RE: St. Lucie Nuclear Plant, Unit 2  
Docket No. 50-389  
Renewed Facility Operating License NPF-16  
Relief Request Number 20 – Request for an Alternative to the Requirements of the ASME Code  
for Examination of Reactor Vessel Closure Head Control Element Drive Mechanism (CEDM)  
Housing #27 Canopy Seal Weld – RAI Response

St. Lucie Unit 2  
Fourth Inspection Interval  
RELIEF REQUEST NUMBER 20 (RR20), Rev. 1

**CSTL2-CR020-TR-CF-000001-NP, Revision 2**

## **St. Lucie Unit 2 CEDM Canopy Seal Weld Overlay Repair**

**Figure 3: St. Lucie Unit 2 CEDM Middle Canopy Seal Weld Modified with Weld Overlay**

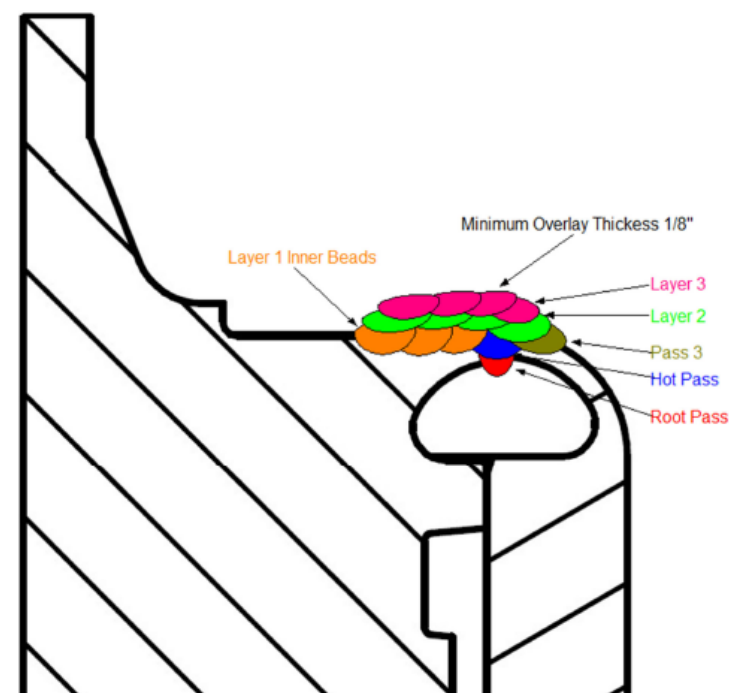
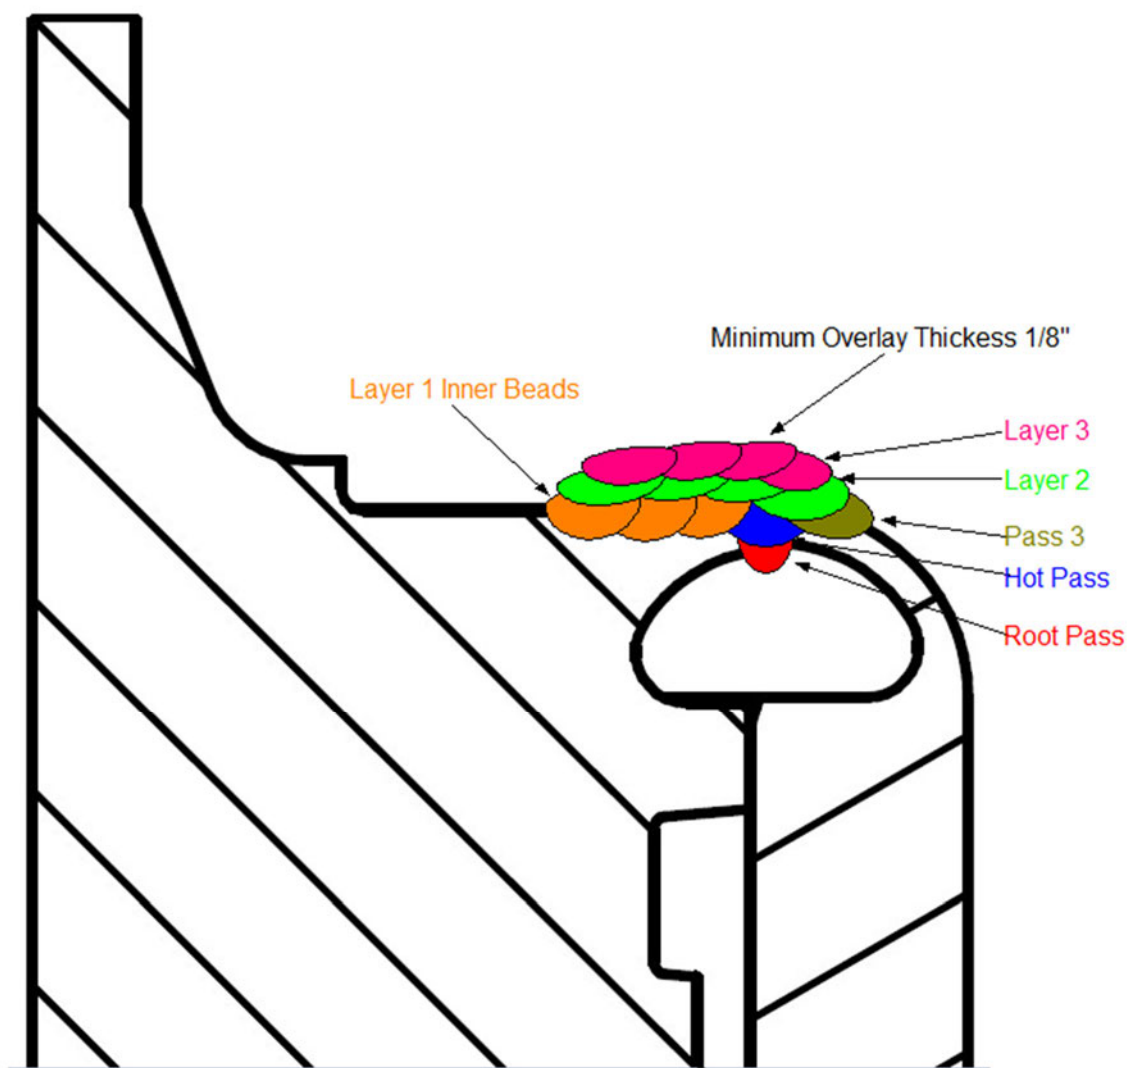
Figure 3 of the relief request and Figure 4-2 of the Westinghouse calculation CSTL2-CR020-TR-CF-000001-P, Revision 1 show the design of the weld overlay. Page 7 of the Westinghouse calculation CSTL2-CR020-TR-CF-000001-P, Revision 1 shows the primary stress of combined weld overlay and canopy seal weld. However, Section 6, page 10 of the Westinghouse calculation states that the wall thickness of the canopy seal weld is assumed to be completely cracked when performing the stress corrosion crack growth analysis. If the canopy seal weld is assumed to be completely cracked in Section 6, explain the technical basis of including the wall thickness of the canopy seal weld in the primary stress calculation on page 7 of the calculation.

The stress corrosion crack (SCC) and fatigue crack growth analysis conservatively assumed a postulated flaw of the original seal weld thickness. It is a conservative and hypothetical scenario. The weld overlay design does not have any flaw at this location.
